City of Albuquerque

RE: DRAINAGE PLAN FOR AN ADDITION TO PARADISE VILLAGE, INC.
(G-17/D34) ENGINEER'S STAMP DATED OCTOBER 8, 1988

DRAINAGE PLAN

A RETAIL BUILDING
FOR PARADISE VILLAGE, INC.
4005 SAN MATEO BLVD. N.E.
ALBUQUERQUE, NEW MEXICO

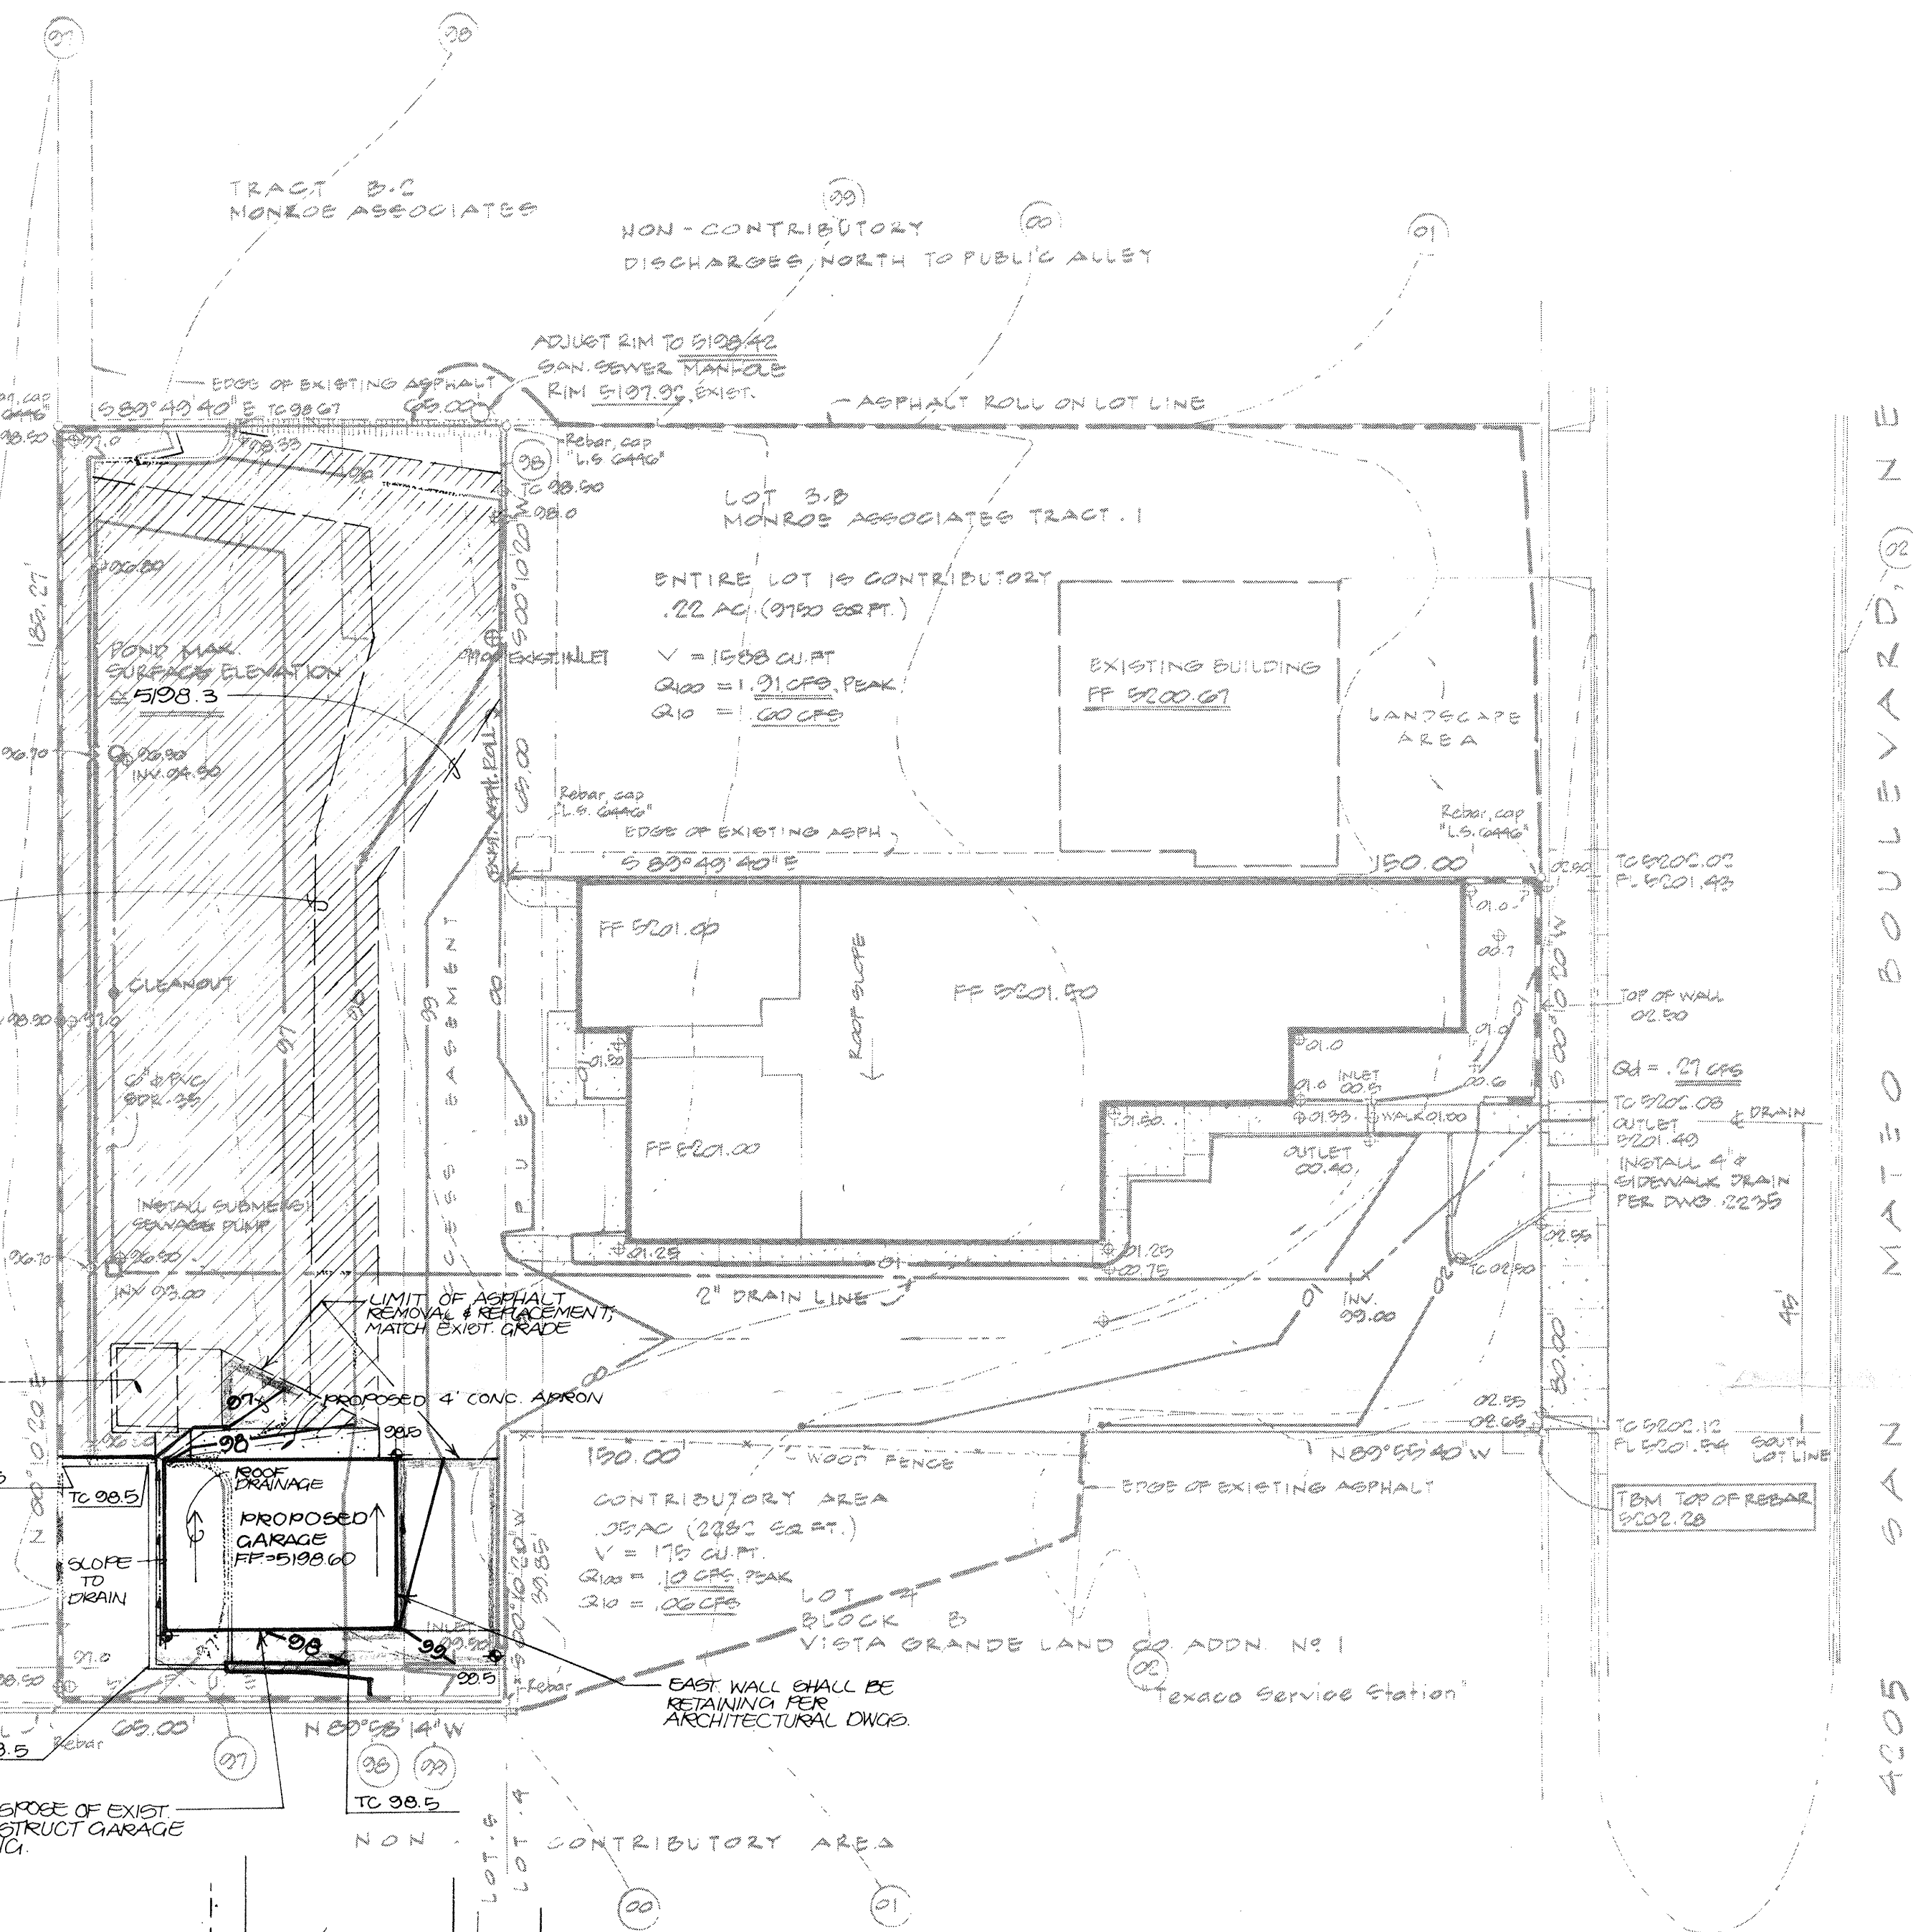
Based on the information provided on your submittal of October 10, 1988, the above referenced plan is approved for Building Permit.

Please attach a copy of this plan to the construction sets prior to sign-off by Hydrology.
